**CITY OF ROCKVILLE PLANNING DIVISION
STAFF REPORT**

Amendment of Detailed Application for
Comprehensive Planned Development CPD2000-
0004G.

Location: Falls Grove Section 3, near Falls Grove
Drive and Falls Grove Boulevard

New Case Number: CPD2001-004G1

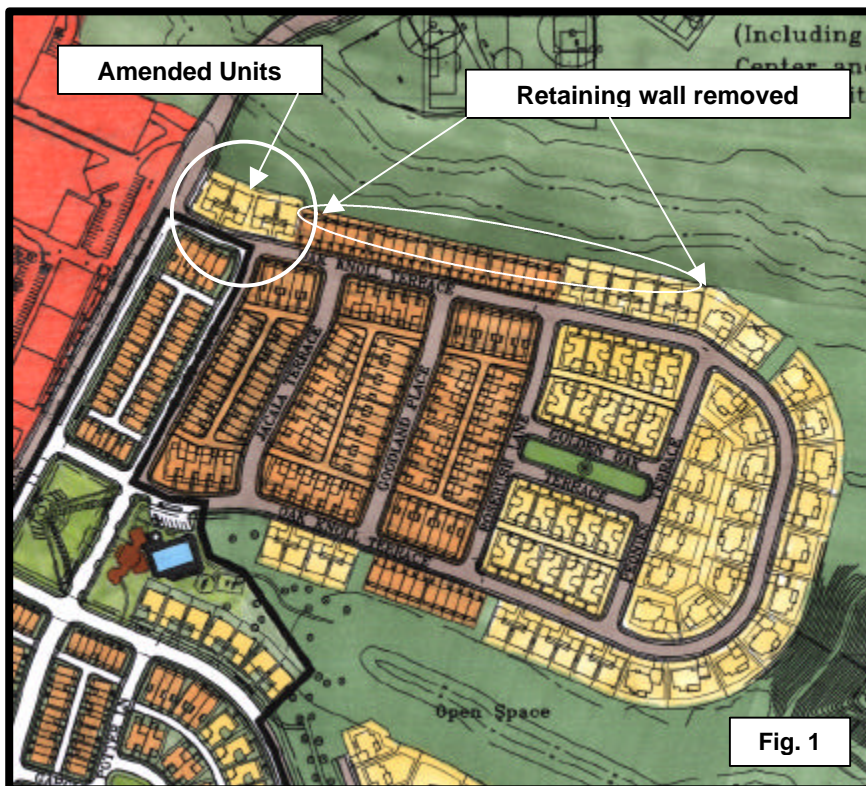
This request is an amendment to a previously approved Detailed Application requesting approval to remove four single family detached units within the R Block (Attachment A) of previously approved

Detailed Application CPD2000-0004G, and replace them with eight townhouse units within two “sticks” of four units each. The request will result in a net increase of four units.

In addition to the above, the original application included a retaining wall behind the line of units highlighted on Fig. 1. This amendment request includes the removal of the retaining wall. Grading behind the units and within the open space eliminates the need for the wall. This grading has been reviewed and approved by the City Forester.

Further, all of the units along the circled area of Fig 1. will shift slightly towards the curve (away from Fallsgrove Drive), due to the relocation of a storm drain line between some of the units, the reconfigured units and the aforementioned grading. The Planning Commission has previously approved the plats for these areas. Amended plats that reflect the changes proposed in this Detailed Application have been submitted for approval immediately following this application.

Staff recommends approval of this application, and the following conditions shall apply:

1. All of the conditions of original approval CPD-0004G shall remain in full effect.
2. Applicant shall provide an amended landscape plan for the R block at the time of signature drawing submittal.
3. Submission, for approval by the Chief of Planning, of eleven (11) copies of the site plan, revised according to Planning Commission Exhibit A.
4. Submission, for approval by the Chief of Planning, of eleven (11) copies of a landscape plan, revised according to Planning Commission Exhibit B.
